核准圖編號 S/H25/4 的修訂 AMENDMENT TO APPROVED PLAN No. S/H25/4

APPROVEDDRAFT WAN CHAI NORTH OUTLINE ZONING PLAN NO. S/H25/4A

PROPOSED AMENDMENTS TO THE APPROVED WAN CHAI NORTH OUTLINE ZONING PLAN NO. S/H25/4

WAN CHAI NORTH REDEVELOPMENT

S/H25/4

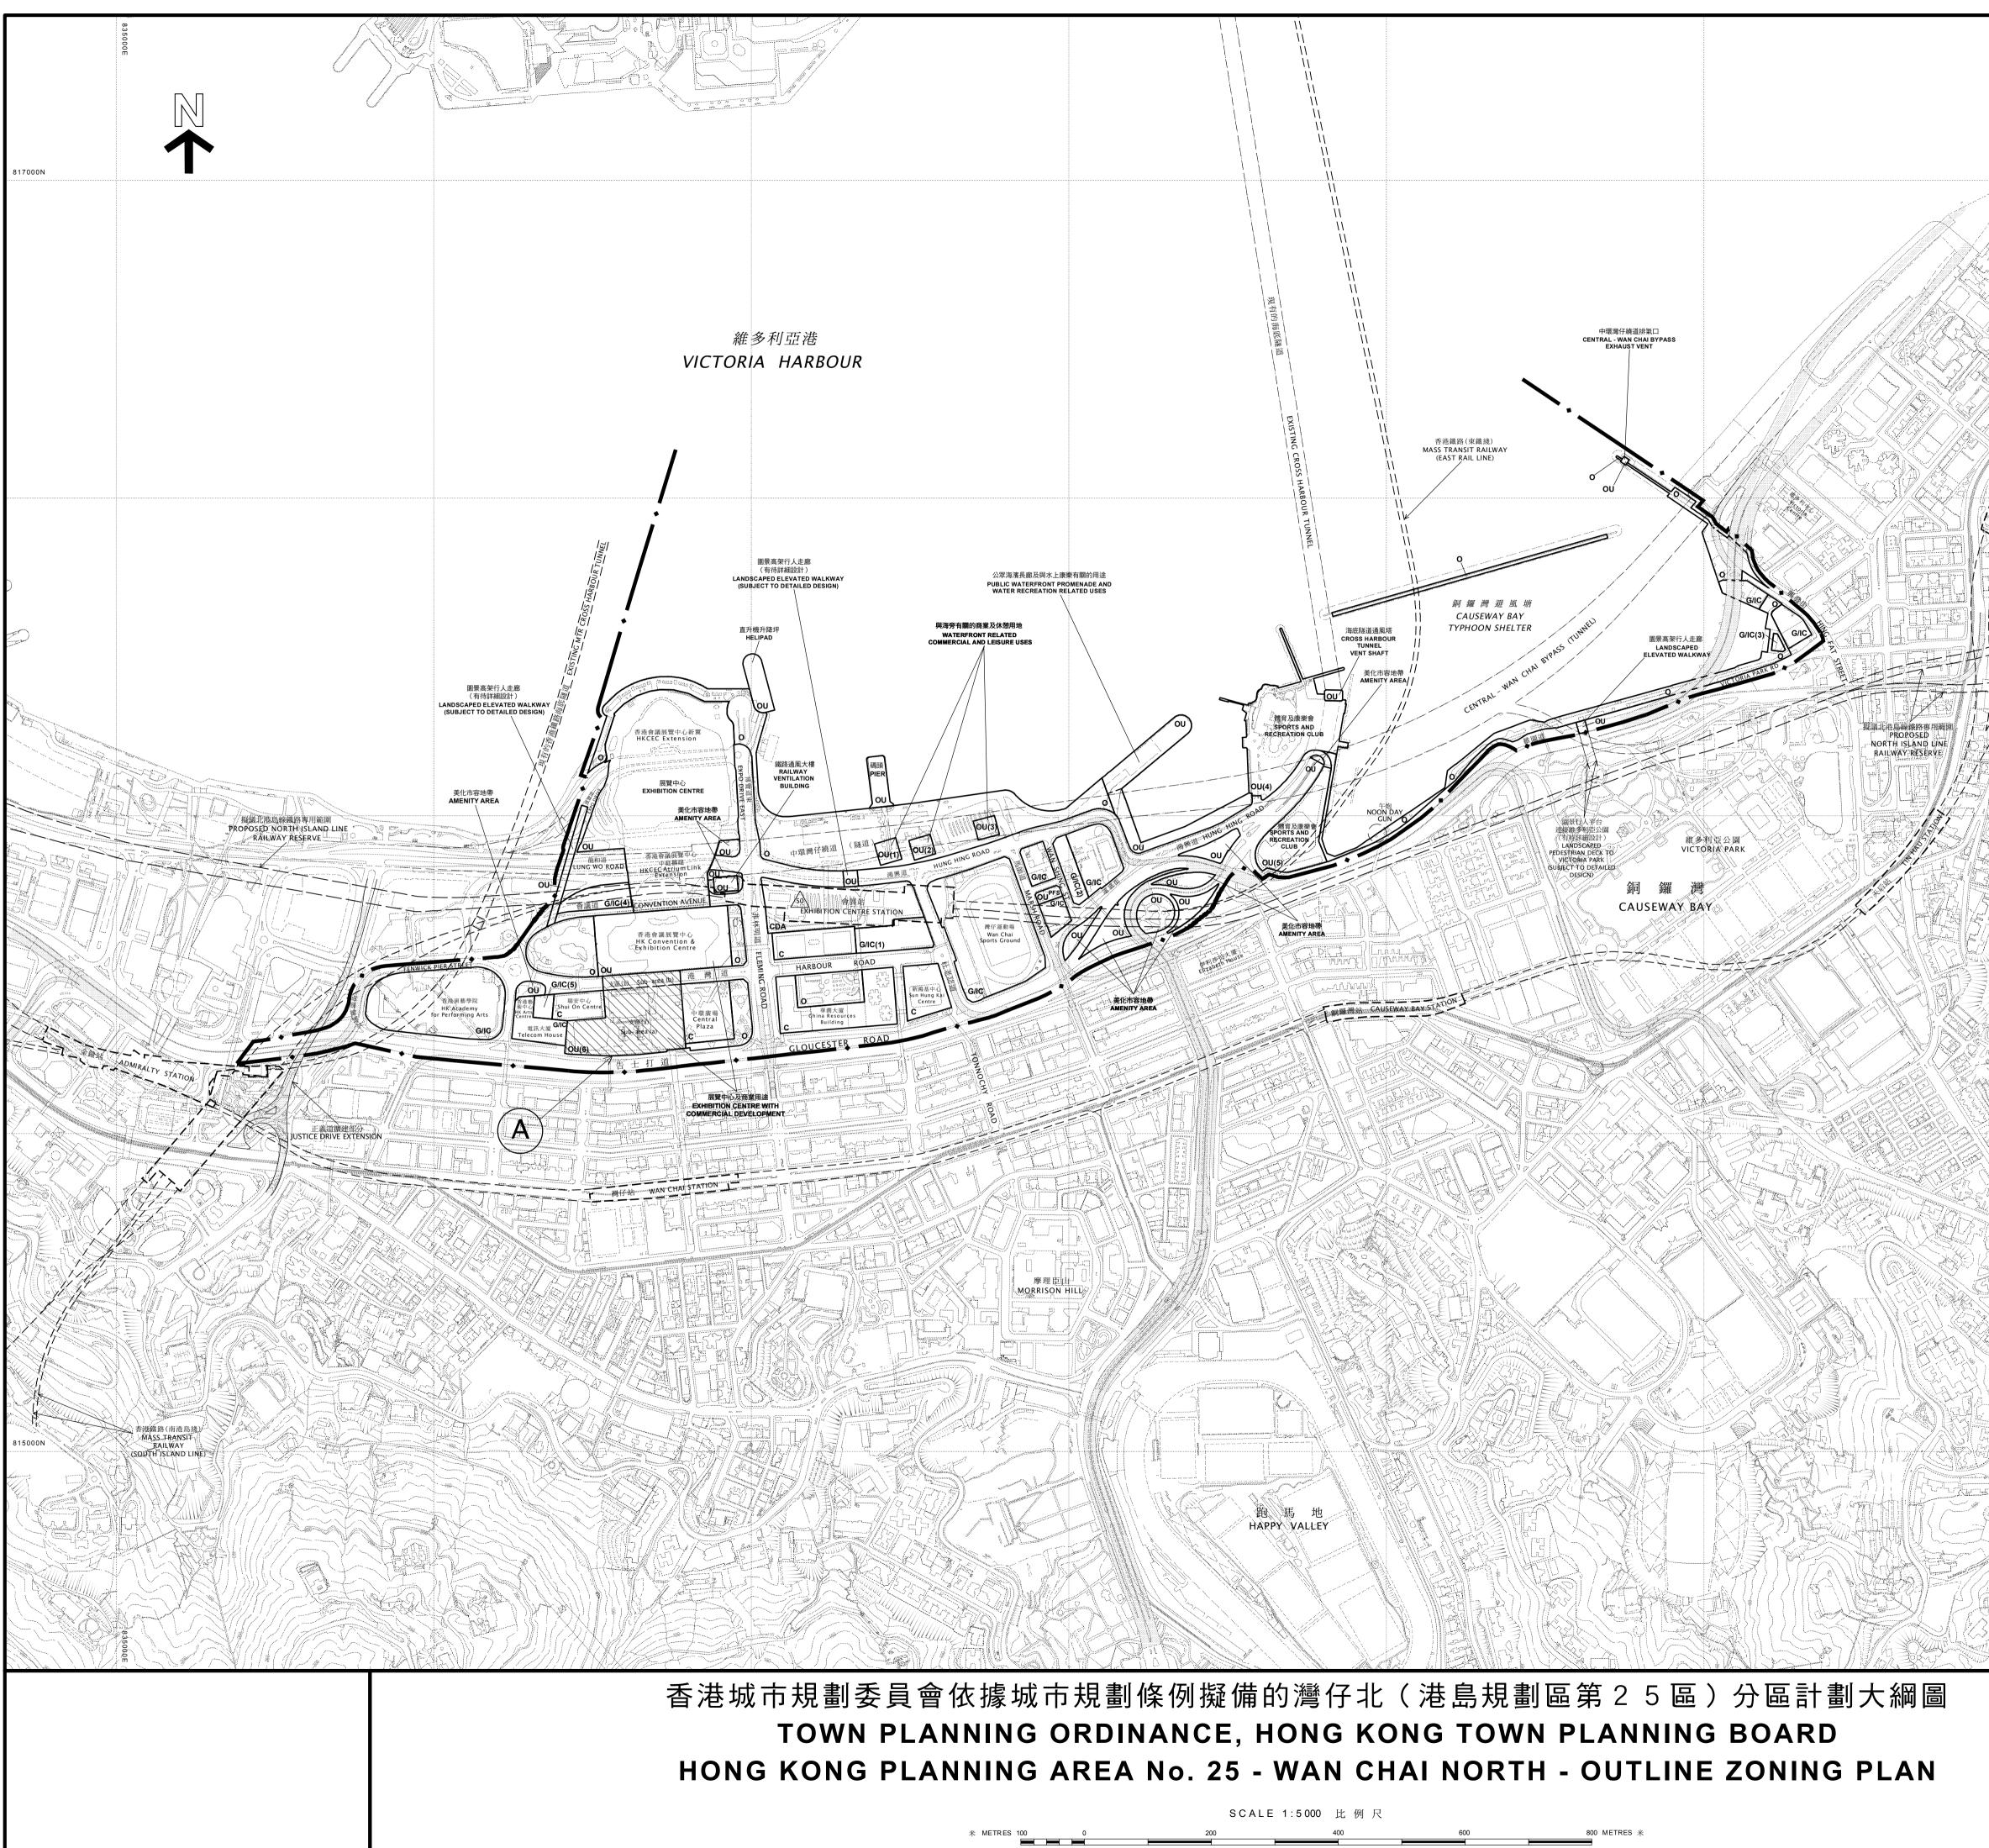
AMENDMENT ITEM A

修 訂 項 目 A 項

(參看附表) (SEE ATTACHED SCHEDULE)

FIGURE 4.1 PROPOSED AMENDMENTS TO APPROVED WAN CHAI (NORTH) OUTLINE ZONING PLAN NO. S/H25/4 SCALE 1 : 5,000

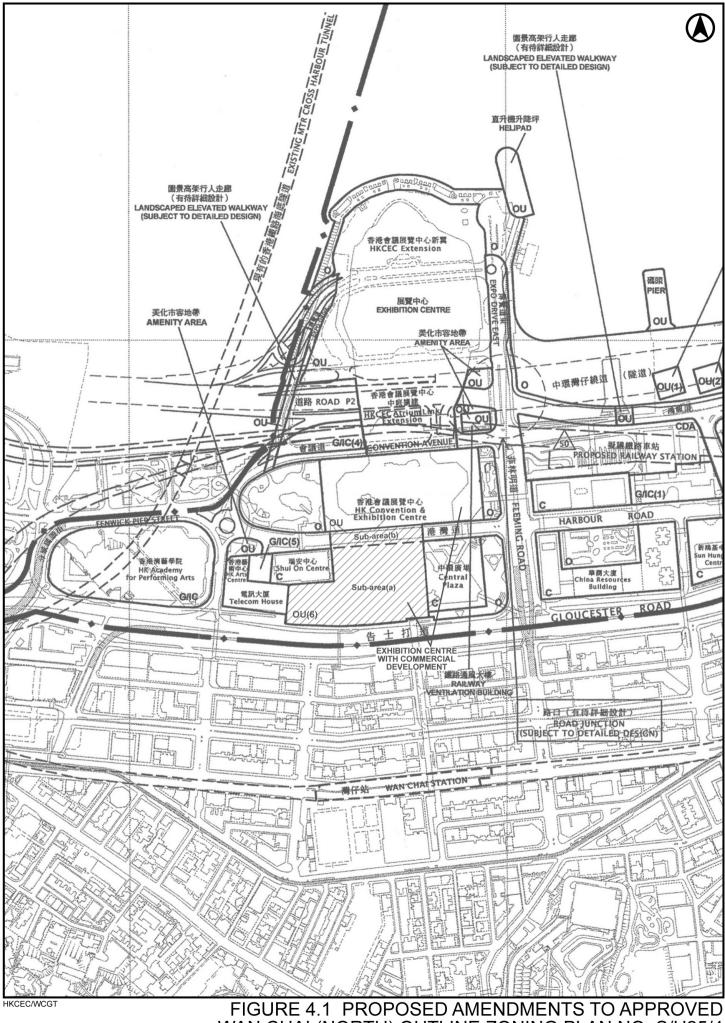
4.1.1 It is proposed to amend the Rezoning Site to "Other Specified Use (6)" annotated "Exhibition Centre with Commercial Development" ("OU6" annotated "Exhibition Centre with Commercial Development"). The Planning Intention of the "OU (Exhibition Centre with Commercial Development)" zone is "intended primarily for the provision of exhibition and convention facilities and commercial and business uses to meet the economic need of Hong Kong." With a view to maximising development potential and to enable seamless with existing HKCEC Phase 1 as demonstrated via the Proposed Development, a maximum GFA restriction of 231,660m², and maximum BHs of 278mPD and 60mPD for the sub-areas (a) and (b) respectively is proposed to be imposed on the Rezoning Site (*Figure 4.1 and 4.2* refers).
